SIB 51 14 20

RATTLE NOISE FROM DASHBOARD CENTER SPEAKER COVER

E-Series	Model Description
G20	3 Series Sedan

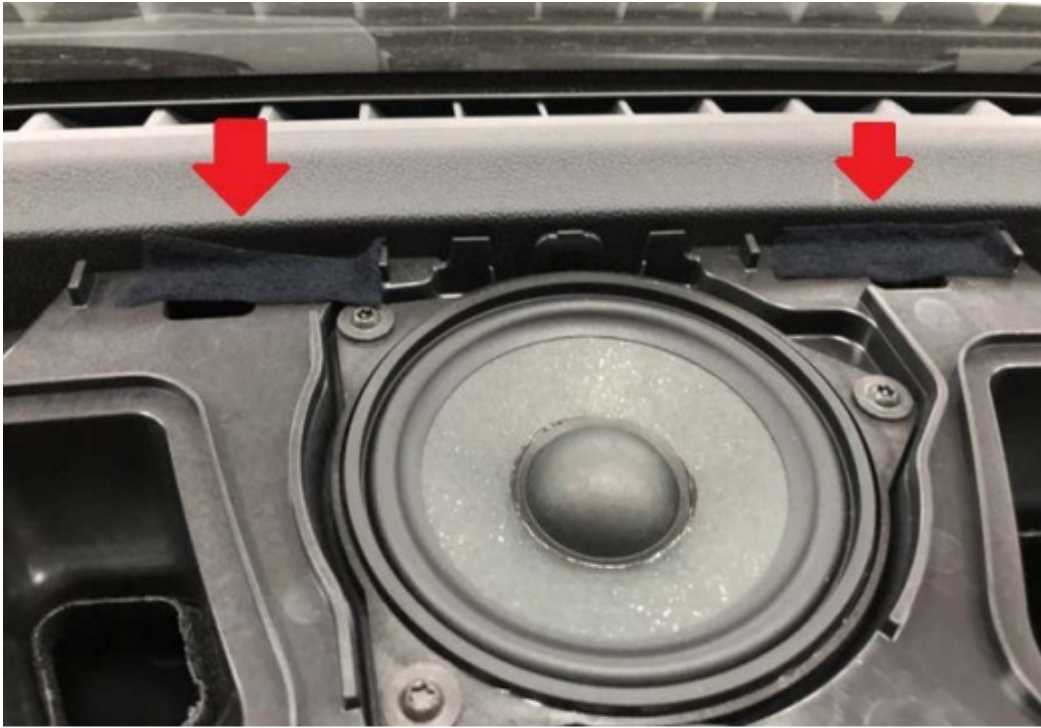
A rattle noise is present from the dashboard's center speaker cover. This may only occur during phone calls, or with certain volumes/tones of music.

Interference between the dashboard speaker cover and the dashboard.

Insulate the speaker cover from the dashboard.

2. Apply any appropriately sized felt strips in the positions shown in the photo below:
